Access Compliance Report

Public Rights-of-Way

(Curb Ramps)

Intersection ID: 7834	Main Street: BILMARK_AV	Cross Street: SNOW_WHITE_LN	Location: SE
ADA ID: 6966329B08B5	Ramp Type: PerpDiag	Initial Pass/Fail: Pass	Overall Compliance: No
Severity Score: 14			
Codes/Mitigation Info/Possible Solution		Field Measurements/Component Compliance

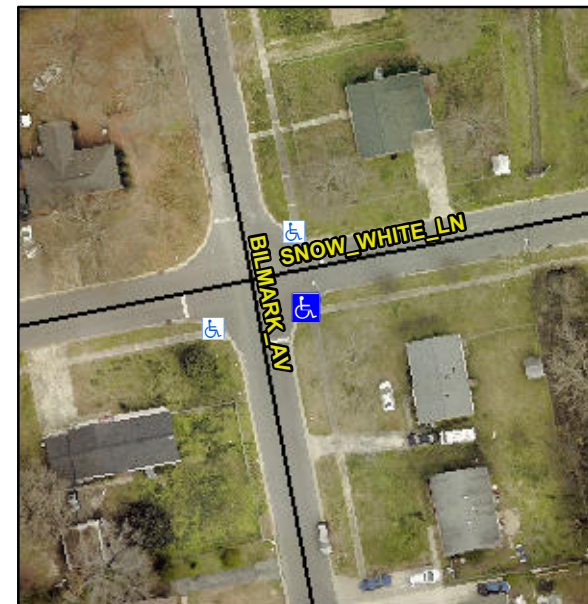
R304.2.1, R304.2.2-Perp, R304.3.2-Para, R305.1.4, R305.2, R302.7, R302.7.2

Remove & Replace Curb Ramp With Two New Directional Ramps or Equivalent. Grind Gutter Lip.
